**RE: COMMENTS OF THE APPALACHIAN MOUNTAIN CLUB ON THE U.S. DEPARTMENT OF ENERGY'S DRAFT ENVIRONMENTAL IMPACT STATEMENT AND SUPPLEMENT FOR NORTHERN PASS, LLC'S, PRESIDENTIAL PERMIT APPLICATION FOR THE NORTHERN PASS LINE PROJECT [DOE DOCKET NO. PP371]**

Modified Figure 3. Diagram of the landscape assessment procedure with types of data used.

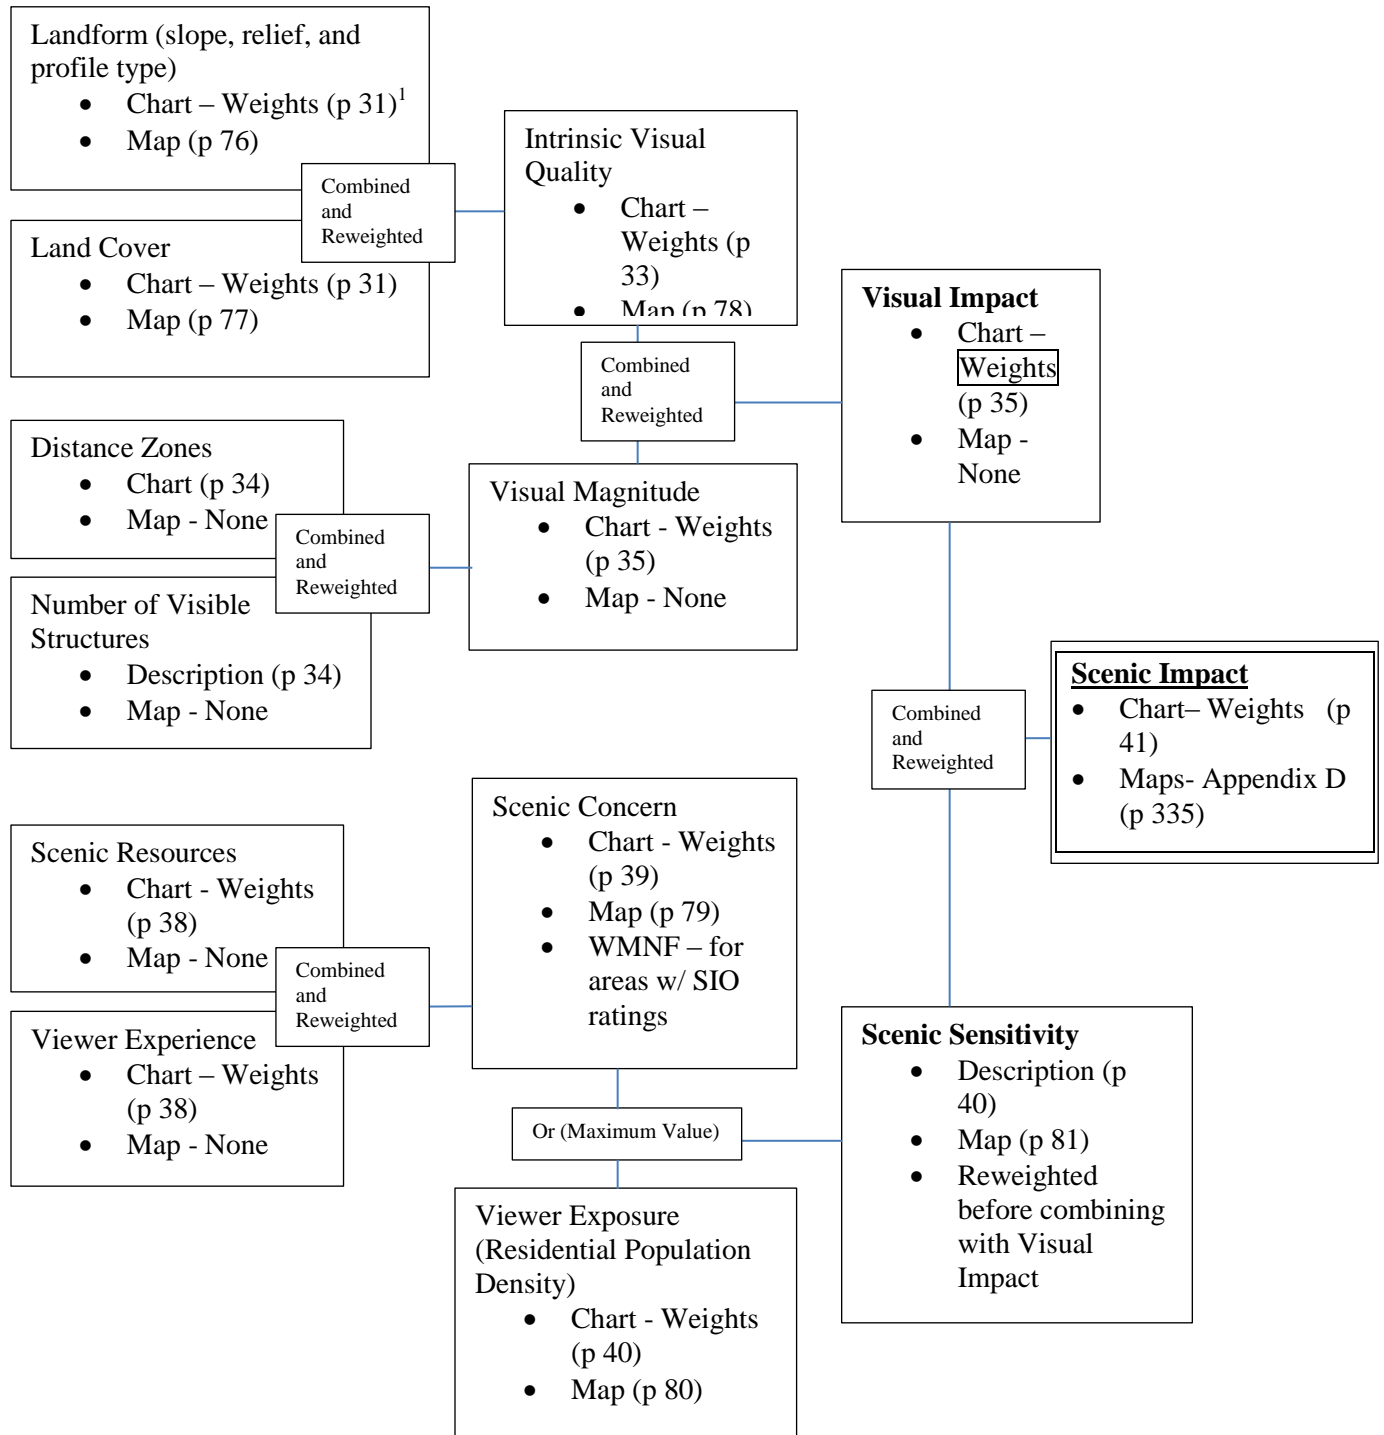
**Approach #1 Big Picture - Landscape Assessment “Scenic Impact Model”:** Landscape assessment is an approach to evaluate the suitability for or potential effects of a proposal. The landscape assessment model that was developed in the DEIS generally follows the approach used in the USFS’ Scenery Management System described in *Landscape Aesthetics: A Handbook for Scenery Management* (USFS 1995). The ultimate model outcome, in this case “*Scenic Impact*”, is very dependent on assignments of rank, coefficients applied, and how problems of non-available data are addressed. The numeric ranking approach used in this analysis<sup>29</sup> to permit quantitative comparisons of the various Alternatives has serious flaws as described in the following sections. These flaws need to be remedied in the FEIS to properly assess the overall visual impacts; otherwise, the magnitude of the Scenic Impact will remain underestimated.

The division of the State into sub regions is reasonable. Specific problems with the model input follow:
